CITY PLAN COMMISSION STAFF REPORT

November 6, 2024

Popeyes at BB North Oak

CD-CPC-2024-00149
Rezoning to UR/MPD (Major Amendment)

SITE PLAN
POPEYE'S LOUISIANA KITCHEN
KANSAS CITY, CLAY COUNTY, MISSOURI
SITE ADDRESS: 9806 N. OAK TRAFFICWAY

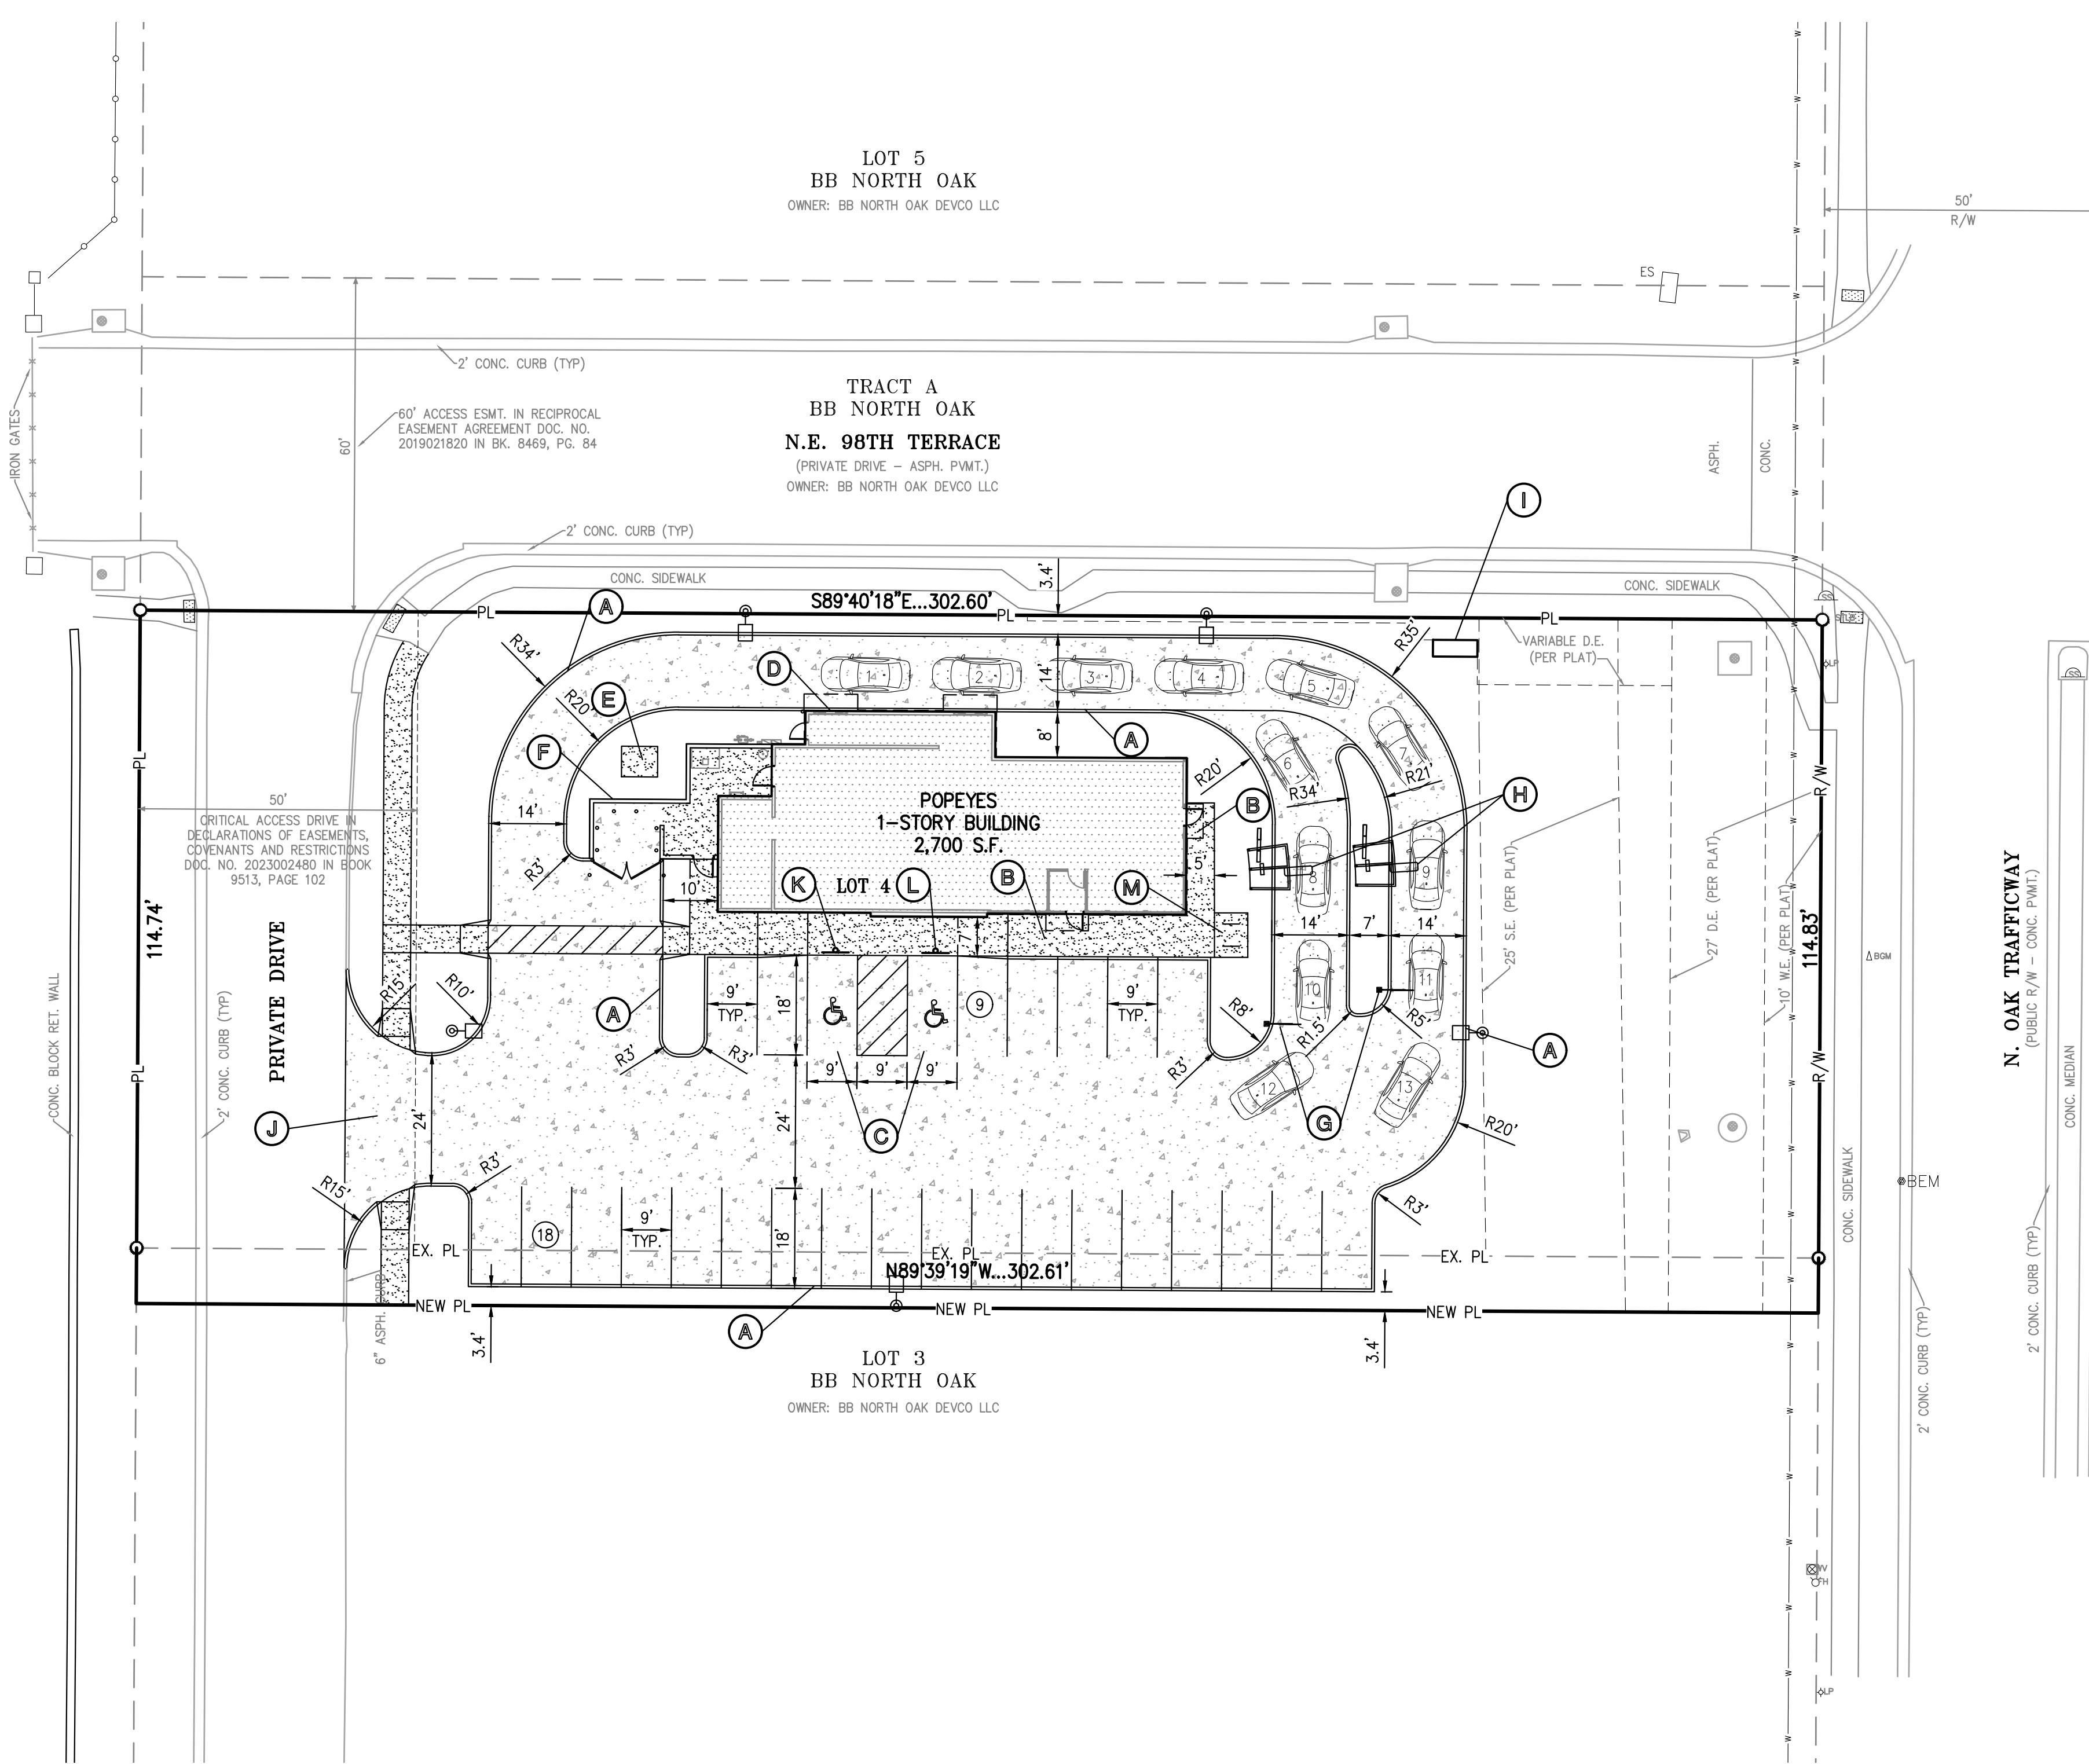
Long Range correction to include sidewalks on the western side of the property and a direct sidewalk connection to the main structure. To better align with the Gashland/Nashua Area Plan and the KC Spirit Playbook, it is recommended that additional landscaping be incorporated along North Oak Trafficway, as this street is designated as a primary image street within the area plan." -Alexis Berra

11. All lighting shall not exceed the recommend levels of the Illuminating Engineering Society on all lots within the MPD.
12. The applicant shall revise plans prior to ordinance request to address Public Works - Mobility's correction: Provide a sidewalk connection from N Oak Trafficway. Right now pedestrian path is to go all the way around to the private drive. It could also go from NE 96th Terr to the east side of the building if preferred.

Landscape Plan
Popeye's
NE 98th Terrace and North Oak Trafficway
Kansas City, Missouri

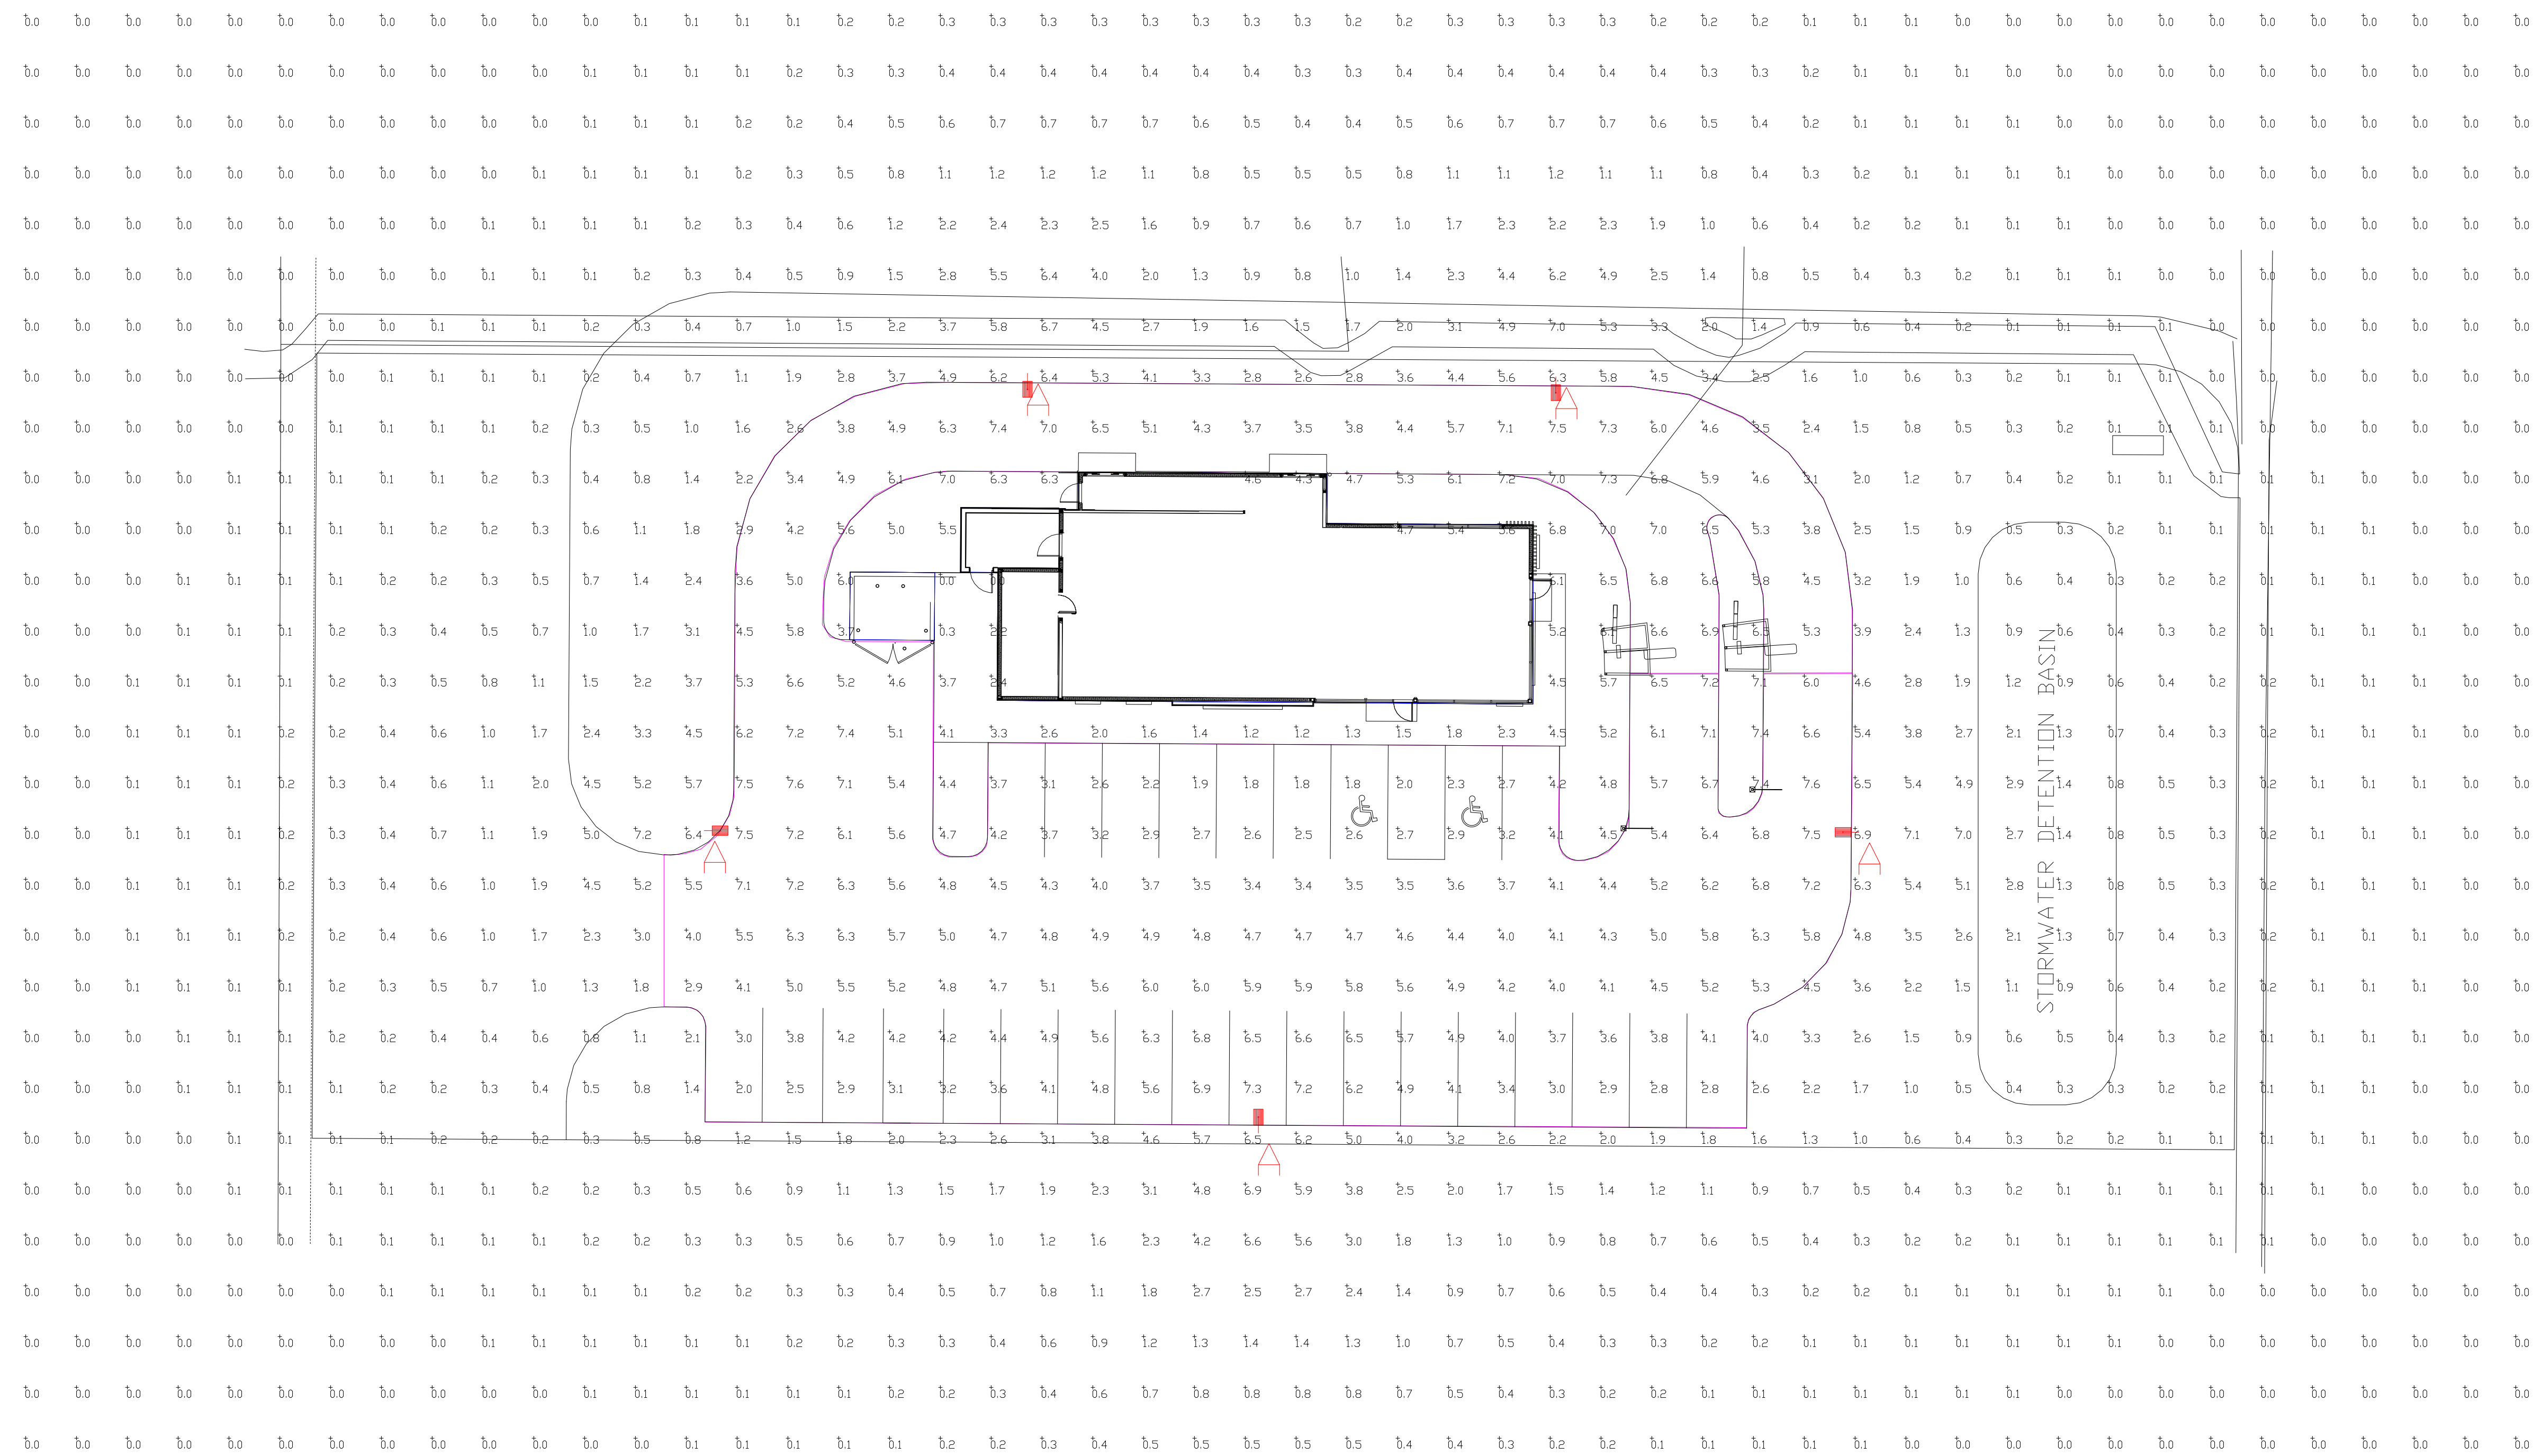
The landscape plan shows screening of the drive-through that meets minimum Code requirements. Proposed shrubs are supposed to be 3 feet after the first growing season, which took the applicant two rounds of review to revise. Although 3 feet is the requirement, staff is concerned whether this will be adequate screening to buffer light, noise, and vehicle emissions from the residences across North Oak Trafficway. Additionally, staff asked the applicant to use native seed mix in the detention basin area to enhance stormwater absorption; however, the applicant declined this suggested revision.

8. That Ordinance No. 220235, including all conditions provided therein, shall remain in full force and effect.
9. The developer shall provide an additional layer of landscape screening along the drive-through fronting N Oak Trfy with varieties of Juniperus virginiana, Thuja occidentalis, or Viburnum.
